Other Regulations:**Regulation No. 123 (Adaptive front-lighting systems (AFS))****Proposal for Supplement 8 to the 01 series of amendments to
Regulation No. 123 (Adaptive front lighting systems (AFS))****Submitted by the expert from the International Automotive Lighting
and Light Signalling Expert Group (GTB)***

The text reproduced below was prepared by the expert from GTB to correct inconsistencies and to introduce provisions to allow for the adaptation to foggy weather conditions. The modifications to the existing text of the Regulation are marked in bold for new or strikethrough for deleted characters.

"Figure 1
Angular positions of passing beam photometric requirements
 (indicated for right-hand traffic)

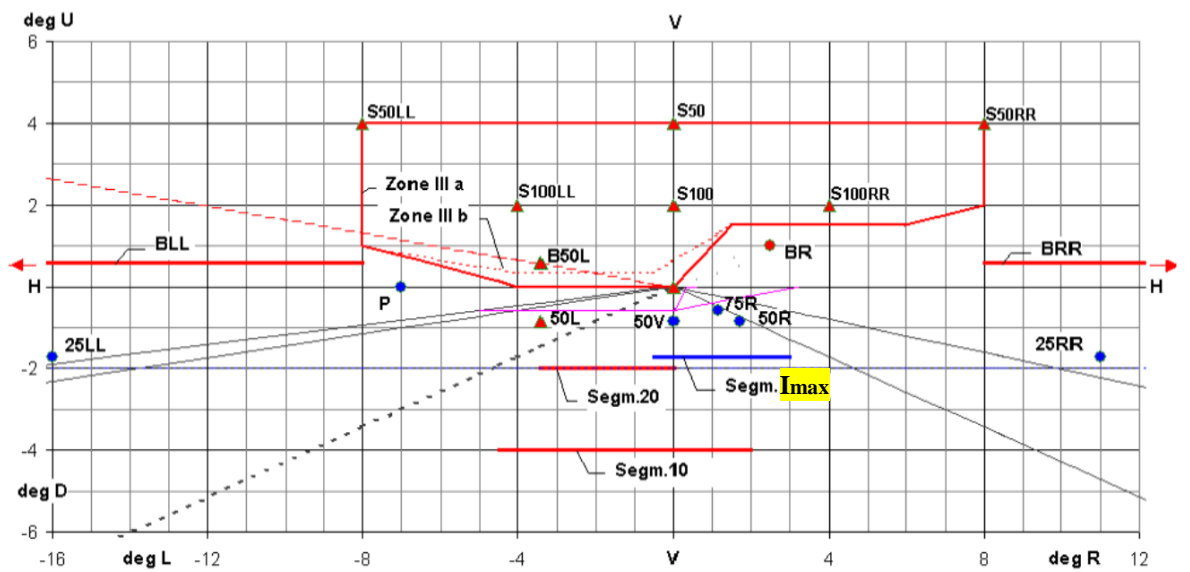
Annex 3, Figure 1, amend to show (change I_{max} is highlighted yellow):
